Zoning & Planning Committee **Report**

City of Newton **In City Council**

Thursday, October 1, 2020

#88-20 Discussion and review relative to the draft Zoning Ordinance

- **Front Facing Garage can align with the Front Elevation with a Front Porch (Sec. 3.4.1.D.1.a)**

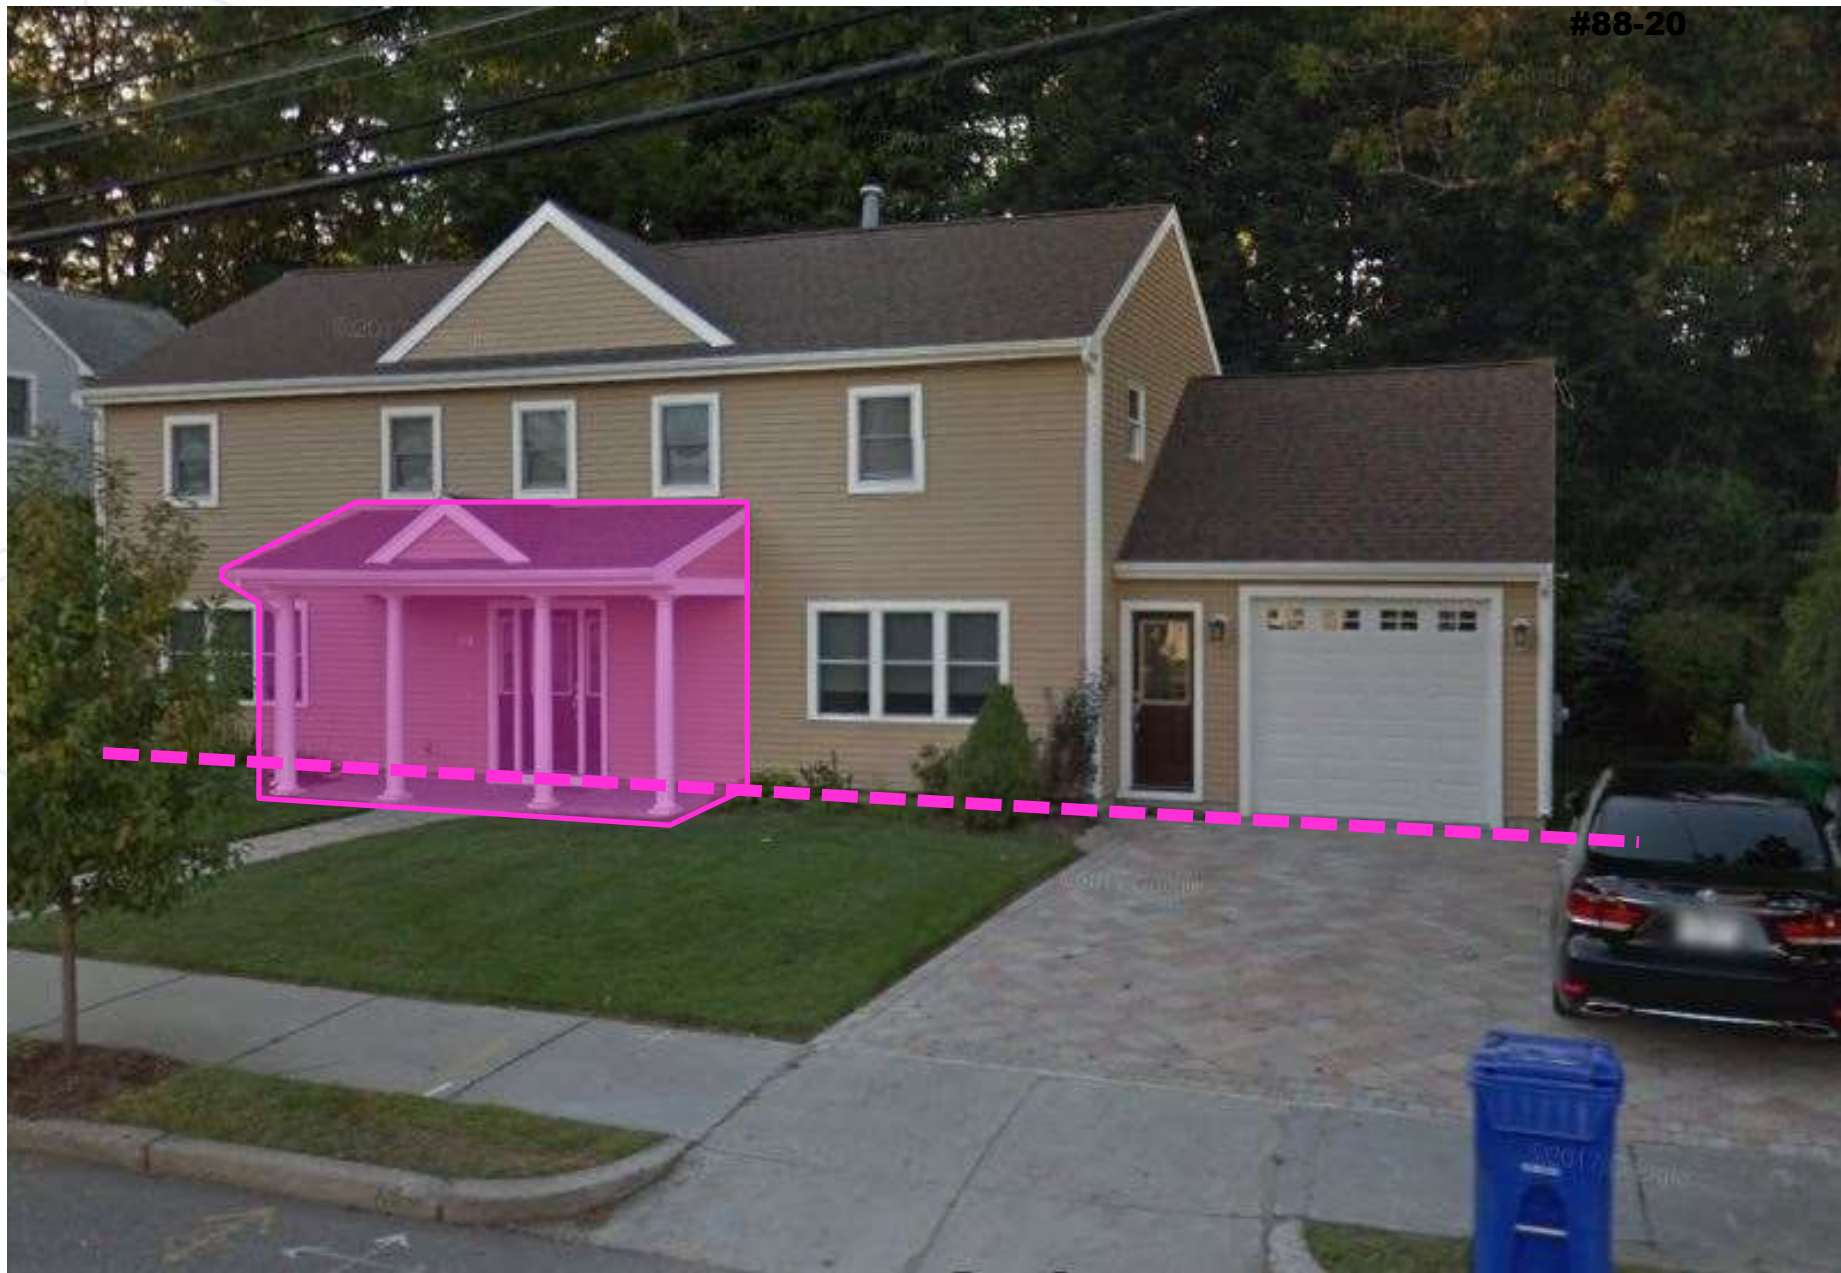
C: Certain designs feature the garage at the front of the house without a porch and look visually appealing. To expand on the question about visual standards after 70 feet, it should be discussed whether this would also exempt garages from the door standards if they are not visible from the street. The three-foot side buffer sounds like a good idea, but this may be hard to achieve on many narrow lots. On shared driveways, it may be good to allow for more parking space to accommodate both neighbors.

A: It does not seem that there was consensus on the Committee regarding garages lining up with the front of the house, even with a porch.

We heard concern over allowing the garage up front with the porch.

C: The front porch concept sounds like a good concept, but it may be wise to include a special permit for this condition. Single-family houses should be allowed to have two curb cuts if they can fit them, especially on busy roads such as Washington Street. Requiring a special permit for this would prevent their overuse.

- **Two car Front Facing Garages require individual doors, each can have a maximum width of 9 ft (108") (Sec. 3.4.1.D.2)**

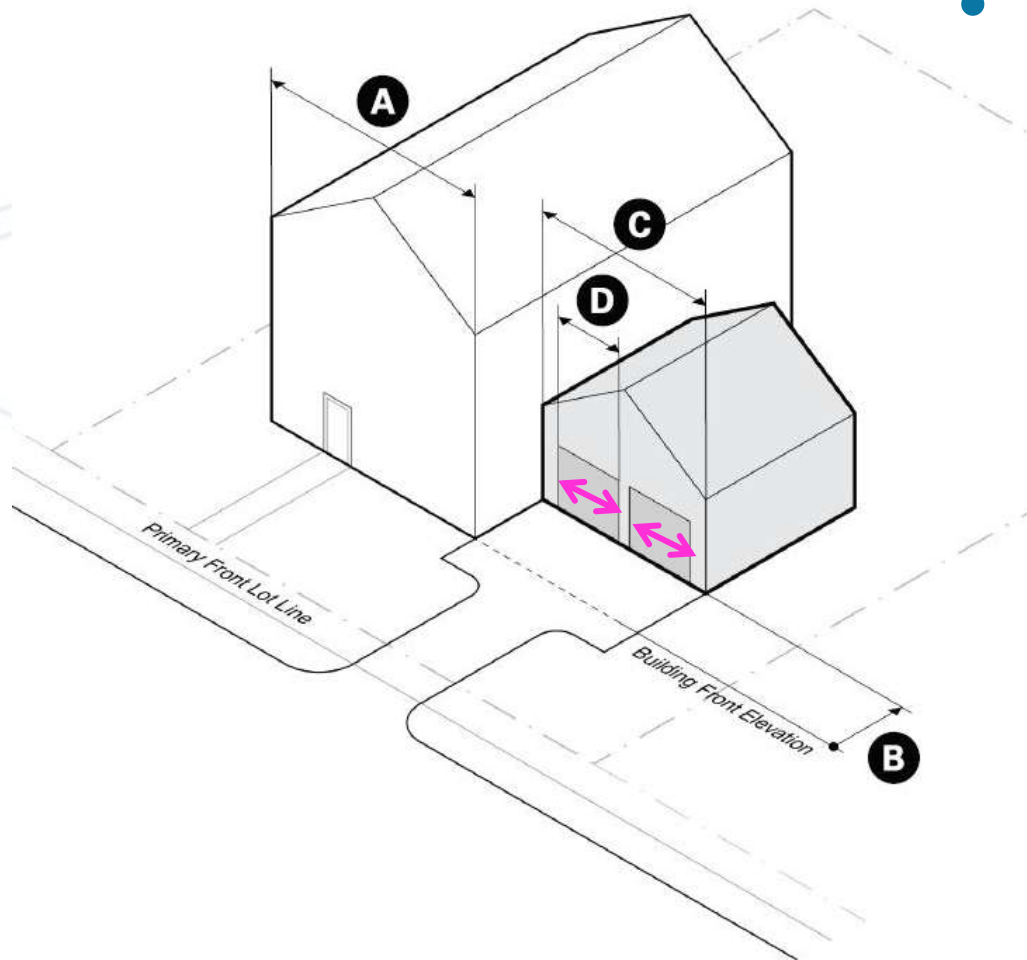
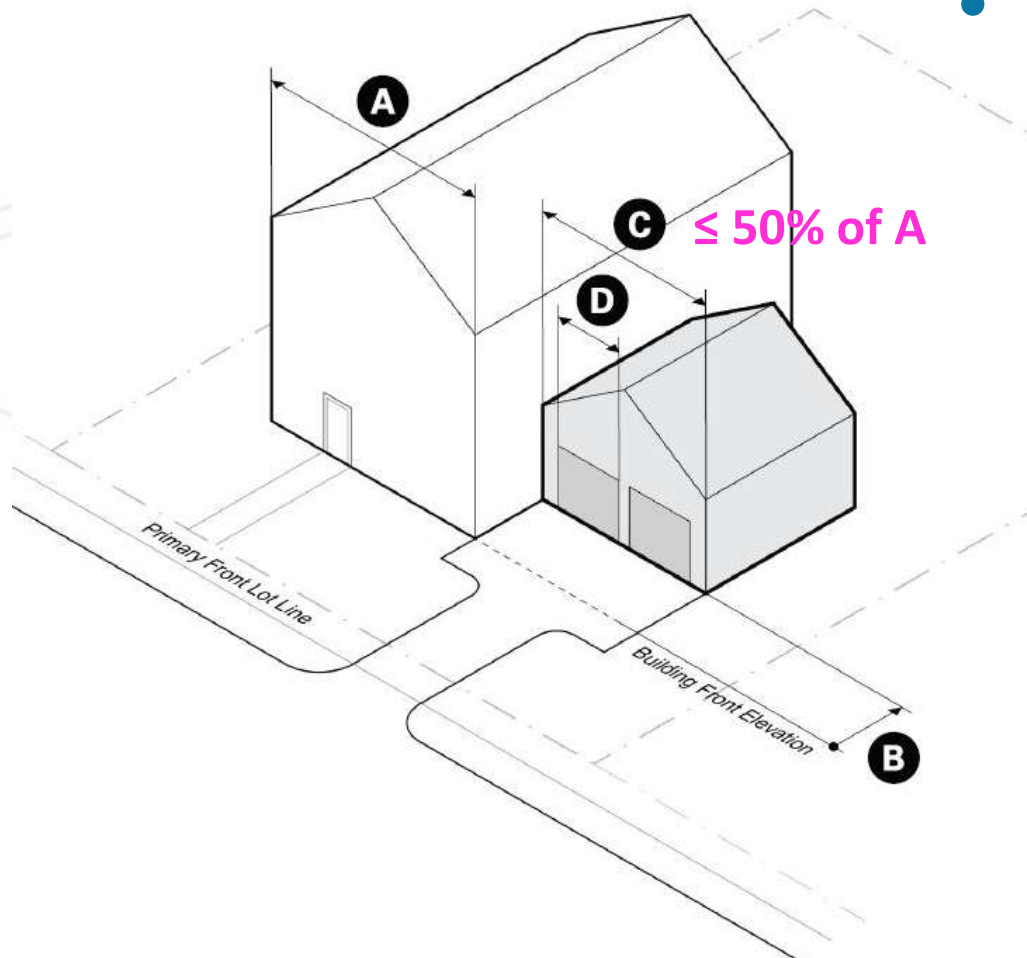
- The proposed ordinance is moving in the right direction on garages
- Garage doors should be no more than 9' wide to reduce the visual impact
- Garages can align with the front of the house if there is a front porch on the home
- The maximum width of a garage being set at 40 percent of the main structure is too restrictive, 50 percent is a better fit.

C: It is troubling that the proposed ordinance seeks to limit the use of special permits while creating more nonconformities at the same time. This is an area Mr. Lee should comment on. Breaking up large garage doors and limiting the garage width to 50 percent of the main house are both good ideas. In section 3.7C of the draft ordinance, it says that a parking space cannot be bundled together with a residential unit. It is unclear how this can be as many parking spaces are, by definition, sold with a home. The 10-foot minimum for driveway extensions on certain lots is concerning as many properties cannot accommodate this. Allowing garages to be closer to the street, yet subservient to the house could be a way to promote less pavement as shorter driveways do not need as much pavement as longer, narrower ones might. This could also interfere with residents’ abilities to park in their own driveways.

- **A Front Facing Garage width (C) can be a maximum of 50% of the Front Elevation (A) for all residential buildings (Sec. 3.4.1.D.4)**

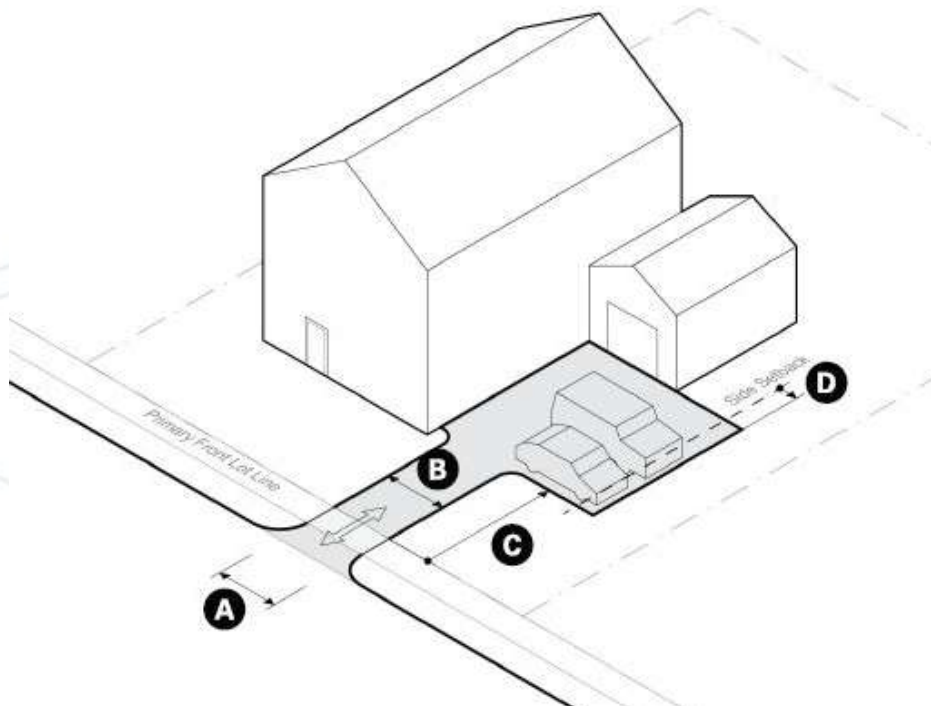
The Chair asked for clarification on whether the previous ordinance intended that a garage could equal the front elevation of the main house or be 50 percent of the combined house and garage. Committee members responded that due to the prevalence of narrow lots within the City, requiring that a garage could only be up to 40 percent of the front elevation including the garage had proved problematic within the deferred ordinance, so the 50 percent of the combined total should be reconsidered.

C: It is good to see the proposed ordinance also addressing walkability and the Climate Action Plan goals. It also demonstrates needed flexibility. Street facing garages should be set back, but the porch feature is a good idea. The 50 percent maximum for garages is also a good idea as it will cut down on their visual dominance. The proposed ordinance should also explore alternative driveway materials such as pavers to reduce the amount of black asphalt, a major cause of heat islands.

- **The maximum width of a driveway is set from the property line and maintained a certain distance into property based on the district (C) (Sec. 3.7.1.E.5)**

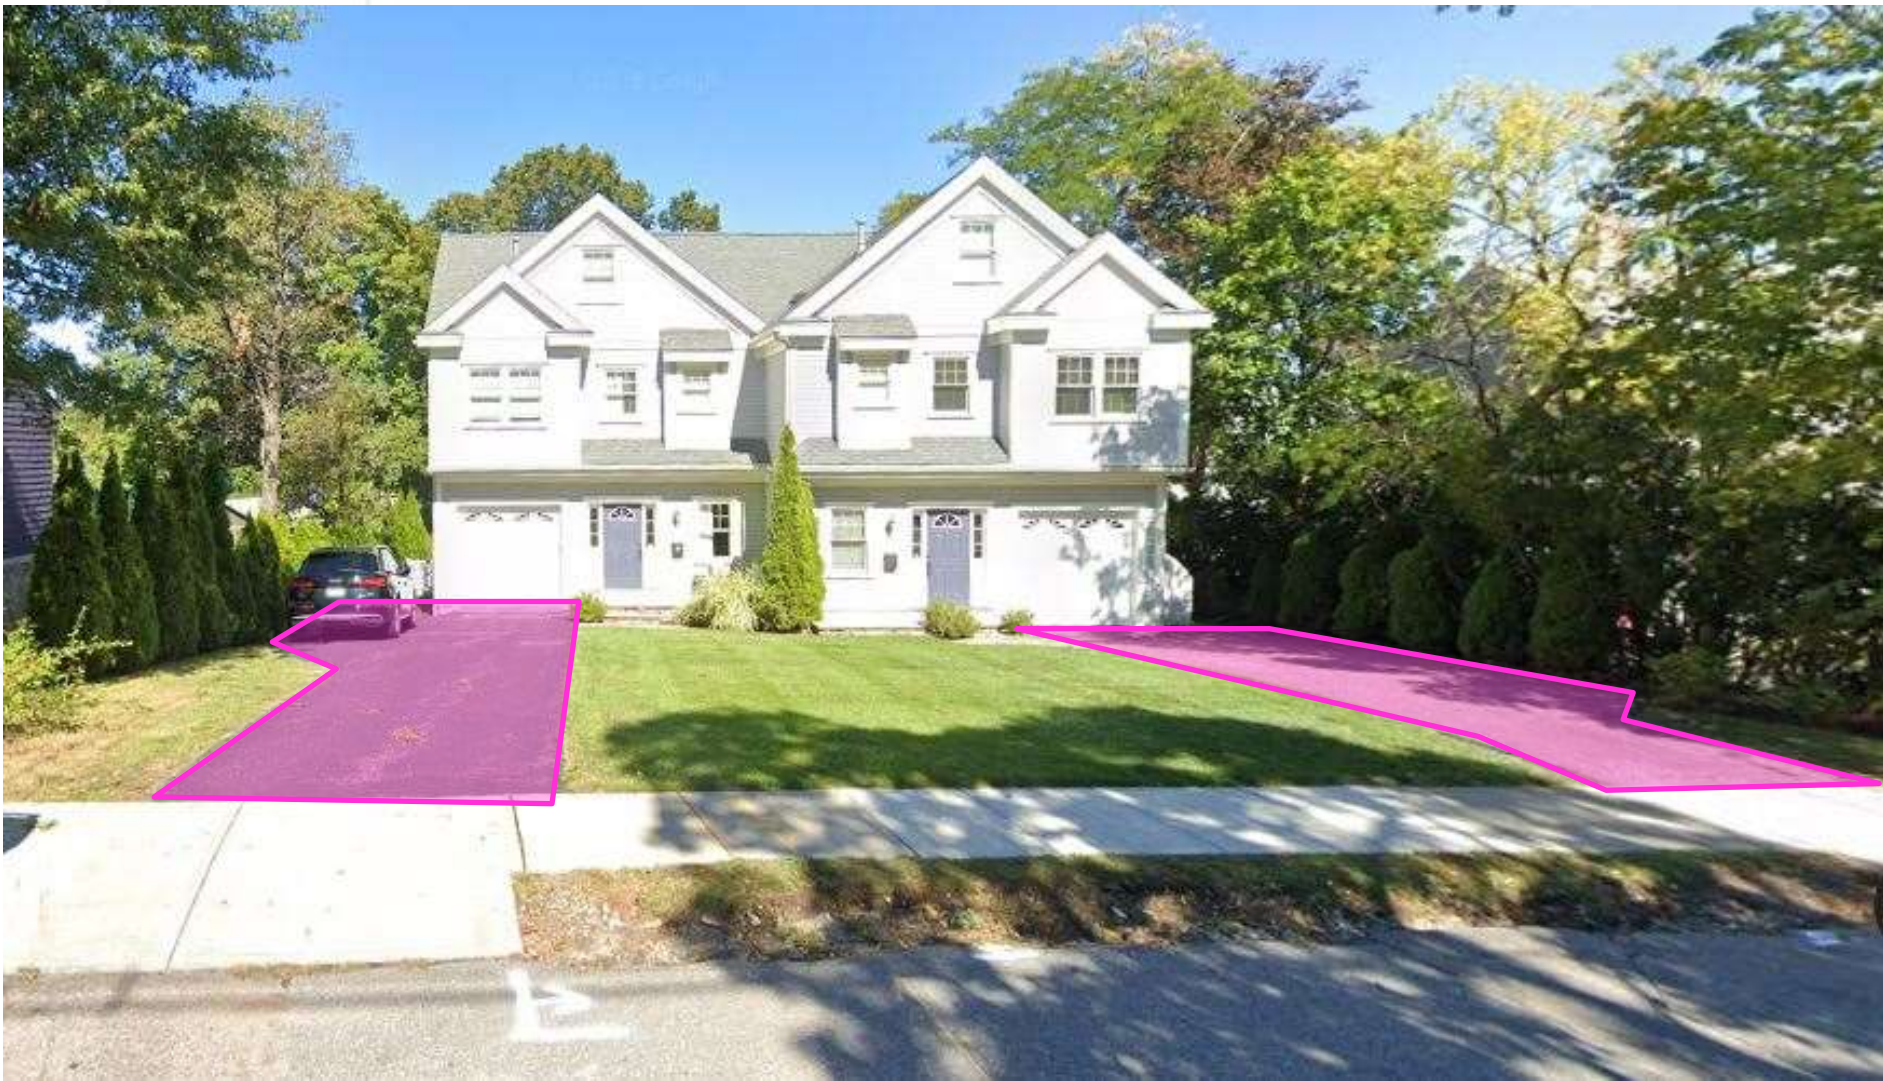
C: The presentation clearly demonstrated the need to limit driveway width as well as the size of the garage façade. Driveways and garages need to be discussed together and more time needs to be allowed for these conversations. Overall the three-foot side buffer seems fine, but special permits should be given on narrow lots. Curb cuts should require a special permit, and double curb cuts should not be allowed because on a busy street, there will also be more foot traffic and double curb cuts are more dangerous to pedestrians. Garages set 70 feet back from the lot line should not be exempt from visual standards because as previously stated, this could allow it to be in front of a house.

C: Many of the older areas of the city such as Newton Highlands have many small and narrow driveways, often under 11 feet. These work fine and are safe for pedestrians as well. These narrow driveways, when next to retaining walls, can create issues with snow clearance, however. Two-car garages within 10 feet of the lot line are visually impactful and should be minimized. Double curb cuts should be handled through a special permit.
